Joint Development Authority
TCAAP Redevelopment Project

RCC Proposed Amendments - TCAAP Redevelopment Code

Date: January 29, 2026
 To: John Mazzitello, Larina DeWalt – Ramsey County
 From: Eric Fosmo, Michael Kirsch – Kimley Horn

PROJECT UPDATE & TRC AMENDMENT DISCUSSION

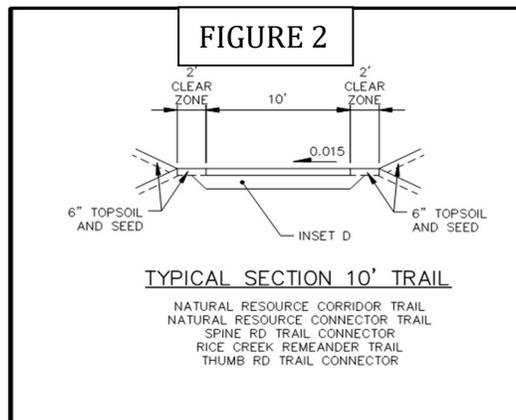
The past design plans, dated 2019, had also planned for 10ft wide multi-use trails throughout the project including all Natural Resource Corridor Trails, Spine Road Trails, and the Re-meander Trail under the future Bridge. See **figure 2** for details.

Rice Creek Blvd - Bridge Railing

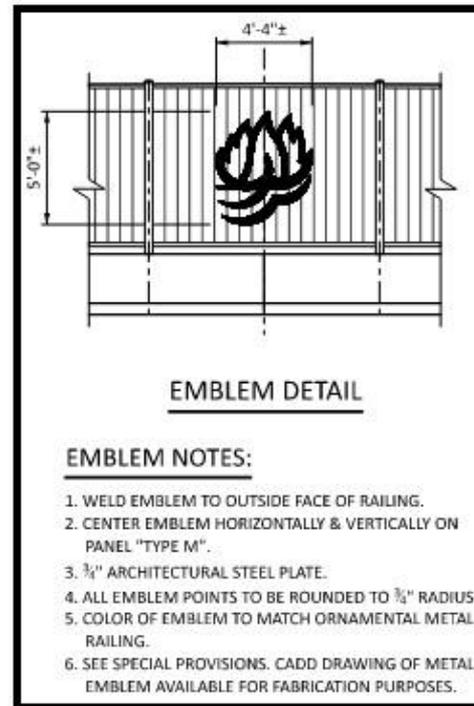
- ▶ October meeting inquiry of adding Arden Hills logo to bridge railing
- ▶ Standard “medallion” approach could add City logo into bridge railing
 - ▶ Approx. Cost - \$5,000
(ornamental railing on south side)
- ▶ Project team needs confirmation from City/JDA and could add detail to bridge plans

Multi-Use Trail Width

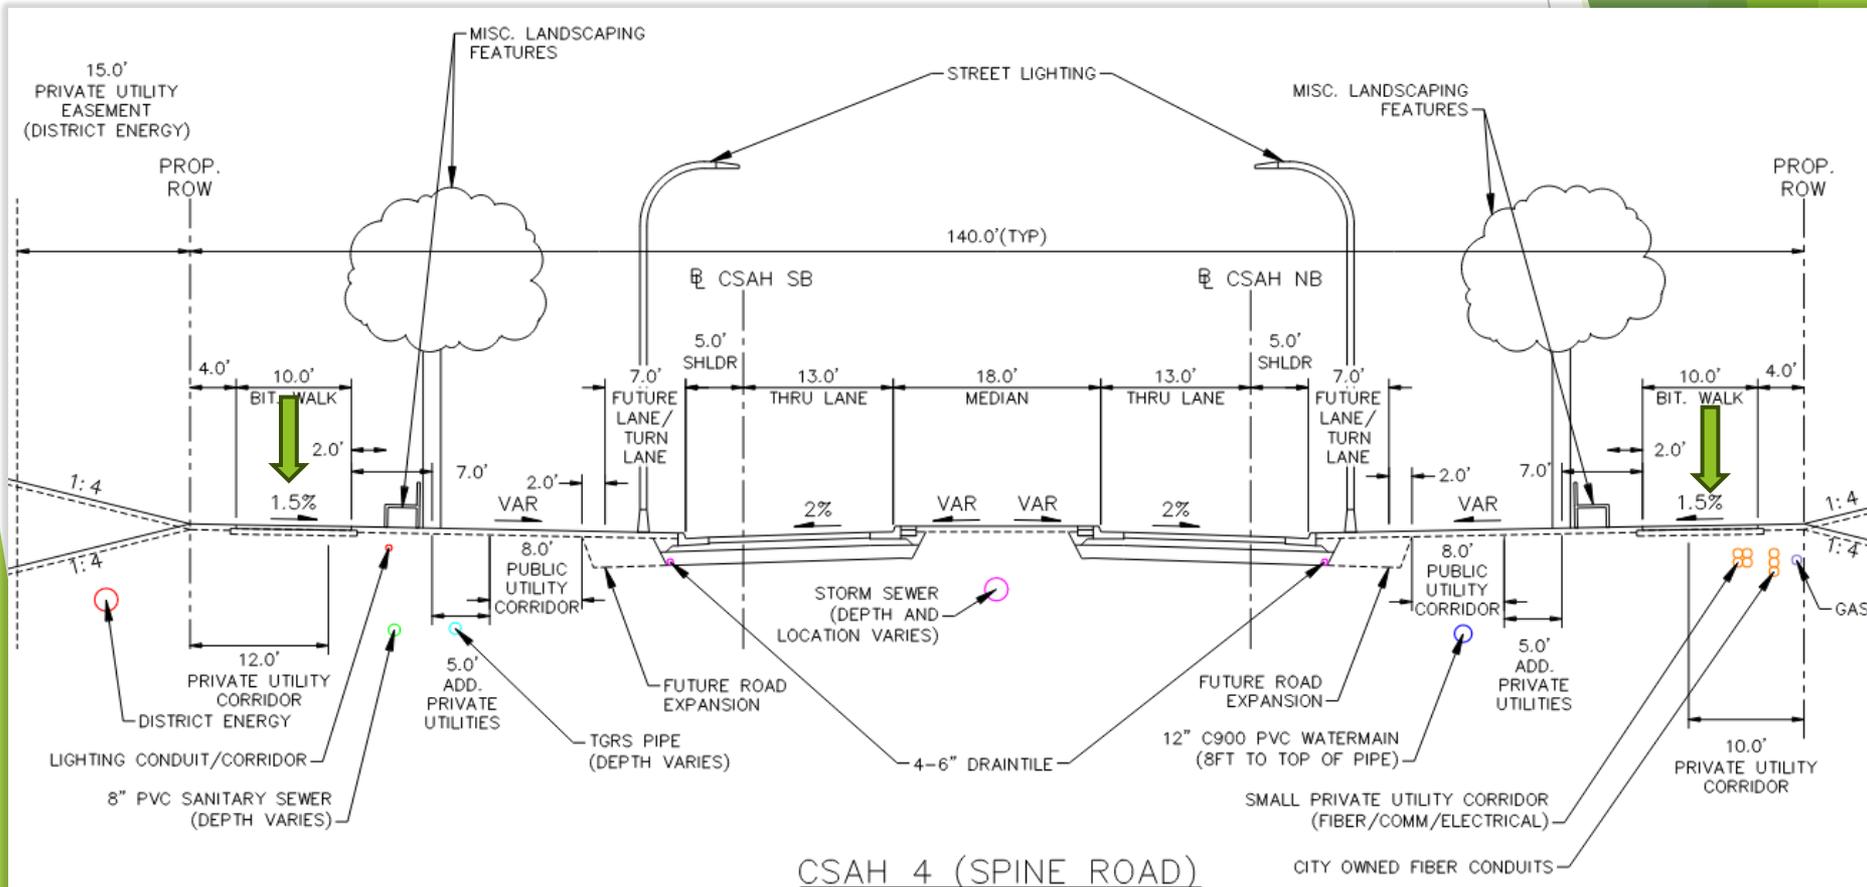
- ▶ TRC Code - 12-foot minimum width
- ▶ Amendment Request: Allow 10-foot width

“Cobra” Style Luminaire

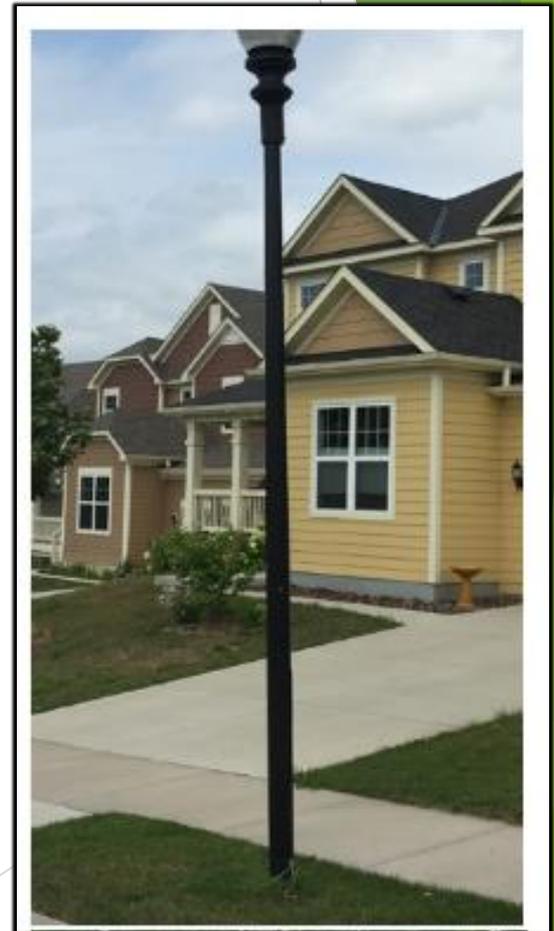
- ▶ TRC Code: Streetlights at 40-foot average spacing
 - ▶ Alternatively, no streetlights would be allowed
- ▶ Amendment Request: Allow for context appropriate streetlight spacing
- ▶ Light selection based on Xcel Energy availability
